SUBDIVISION COMMITTEE
METROPOLITAN AREA PLANNING COMMISSION

STAFF REPORT
(One-Step Final Plat)

CASE NUMBER: S/D 99-61 - FIRST ADDITION TO BENTLEY FARMS

STAFF REPORT
(Final Plat, Preliminary Plat Approved 10/21/99)

"FIRST ADDITION TO BENTLEY FARMS"

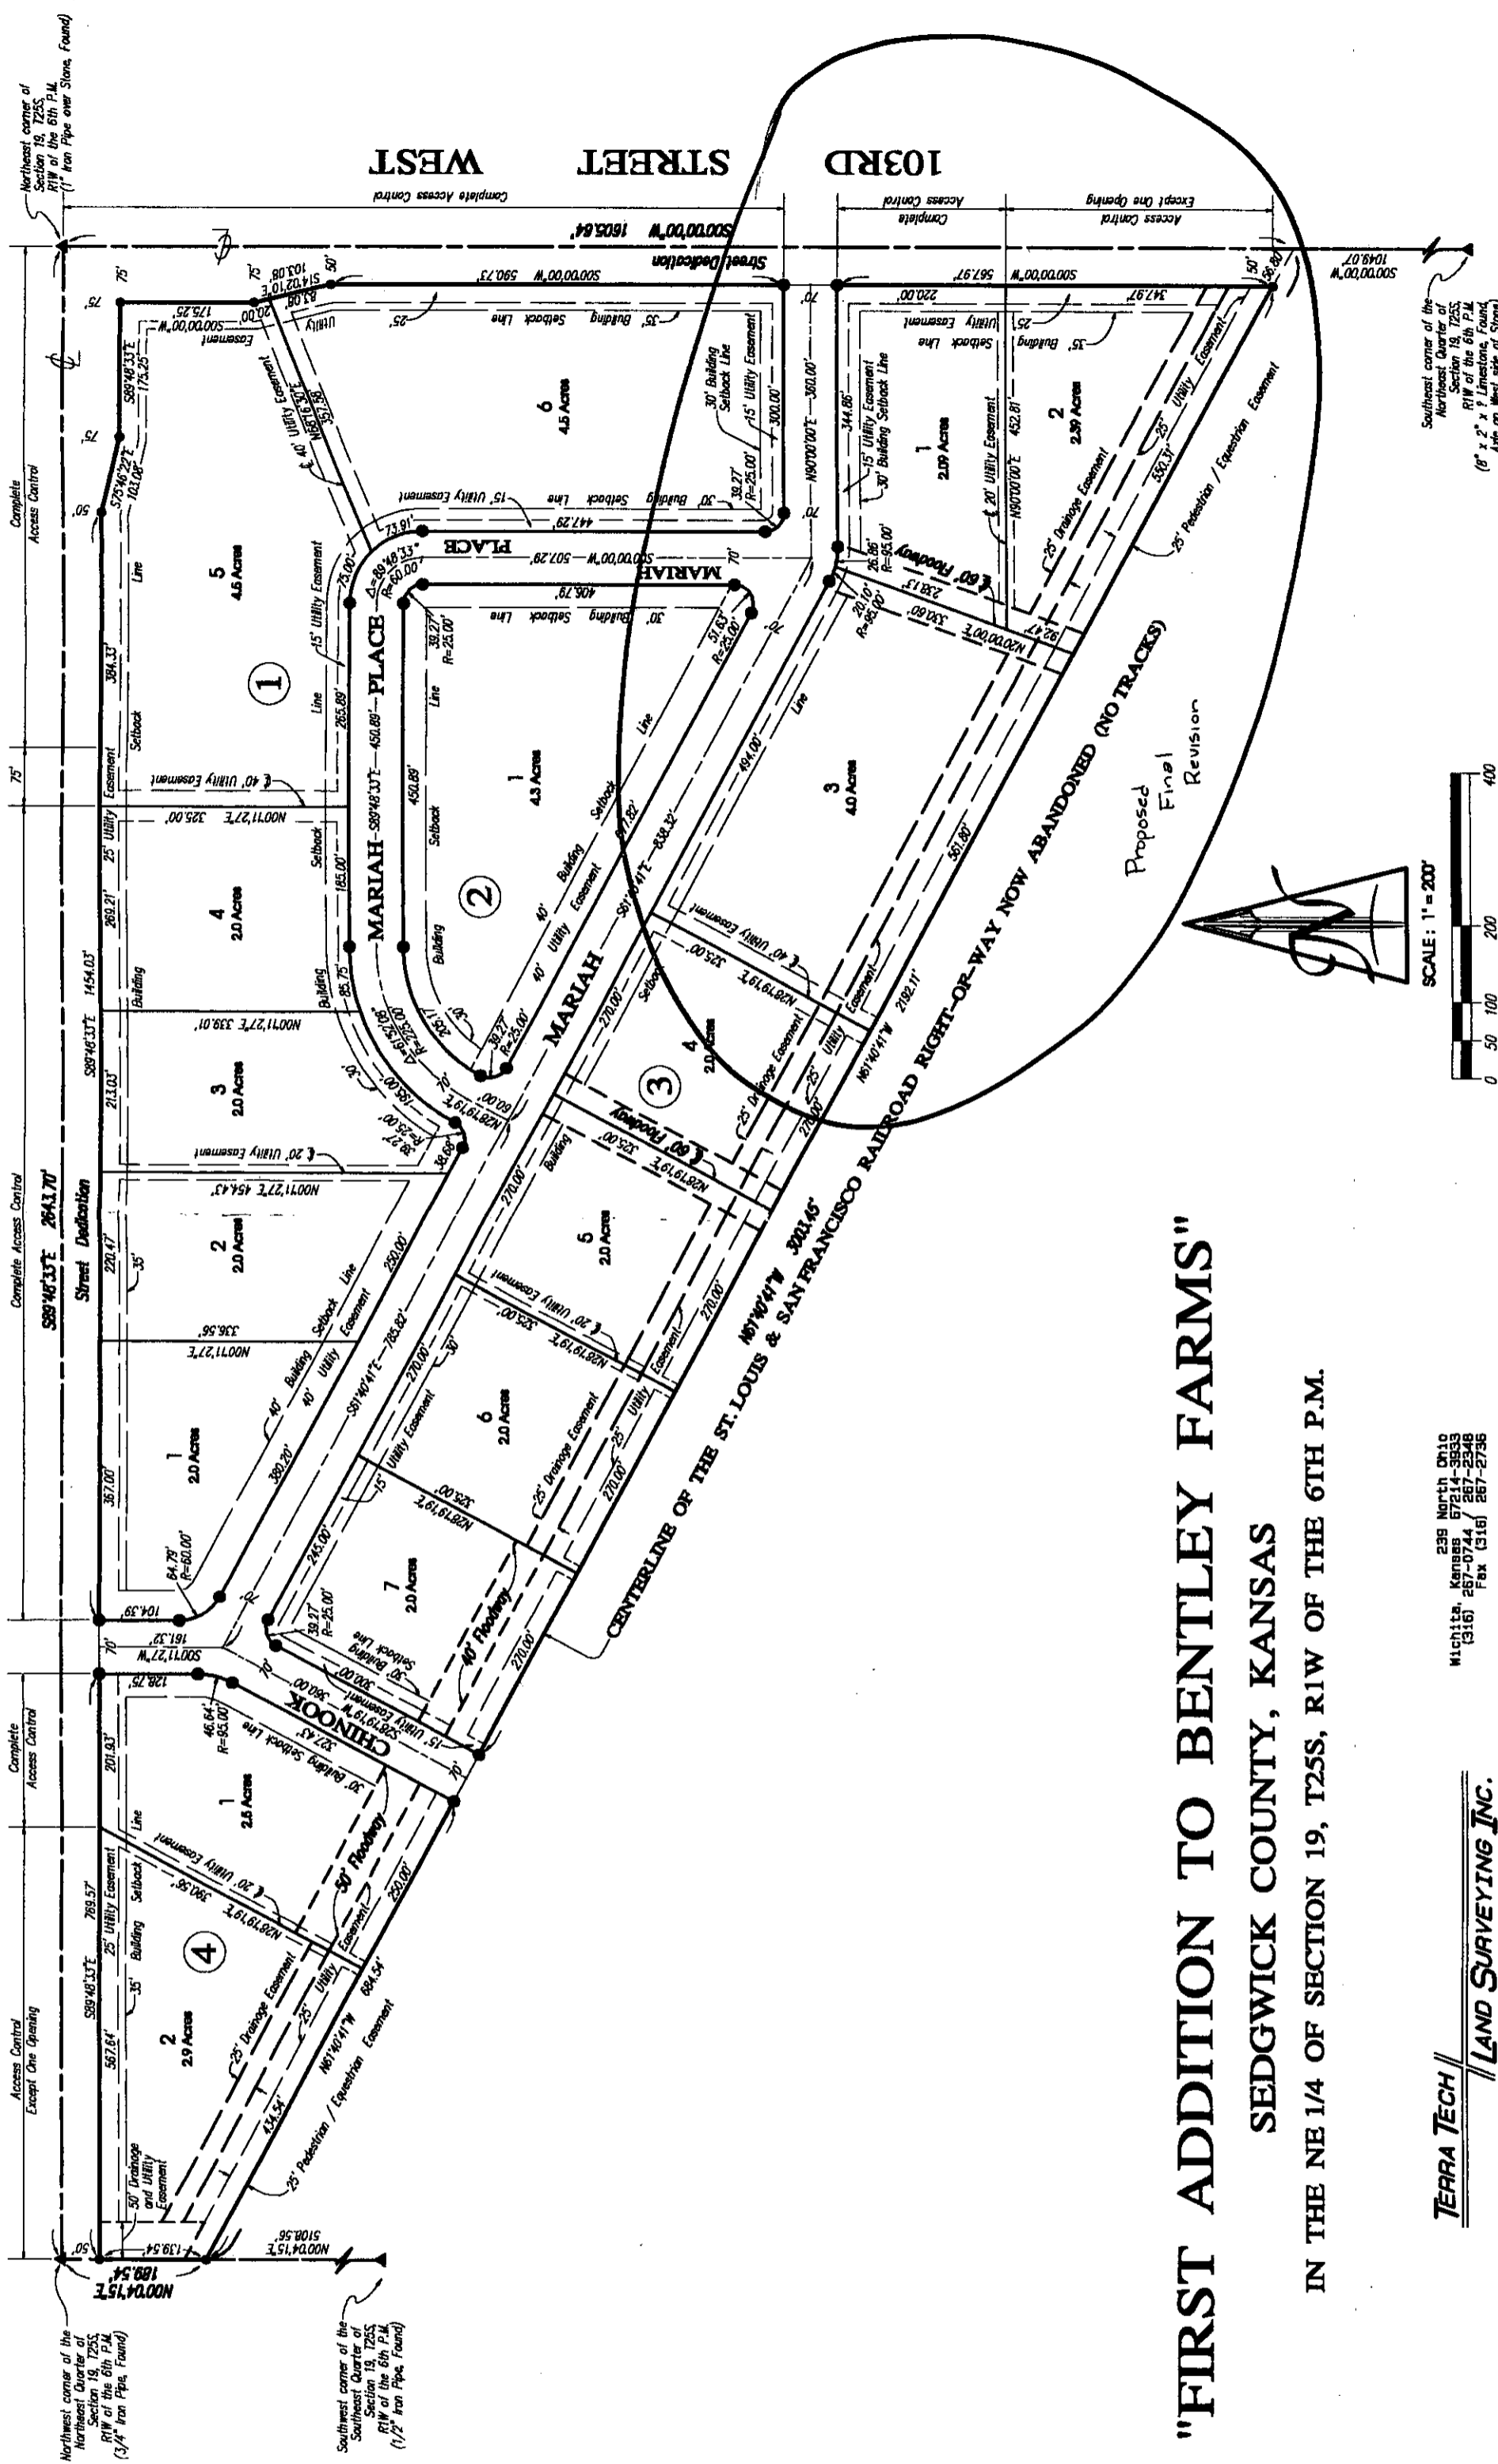
- C. County Engineering needs to comment on the status of the applicant's drainage plan. The drainage plan should include calculations and contours, and denote elevation of existing drainage structures. The proposed drainage detention appears to have no flow outlets.

- D. County Engineering needs to comment on the access controls. Complete access control is required along 103rd St. West for Lot 5, Block 1 at the intersection. This lot may have one opening along 101st St. North to be located within the west 75 feet of the property.

- H. The instrument submitted establishing the Derby Oil pipeline appears to indicate that the pipeline is encumbering this plat. If so, it shall be shown and subject to the standard pipeline conditions.

- S. County Engineering has requested a 25 foot utility easement adjoining a 25 foot pedestrian easement at the southwestern line of the plat.

The final plat has denoted the requested access controls.

The requested utility easement has been platted.
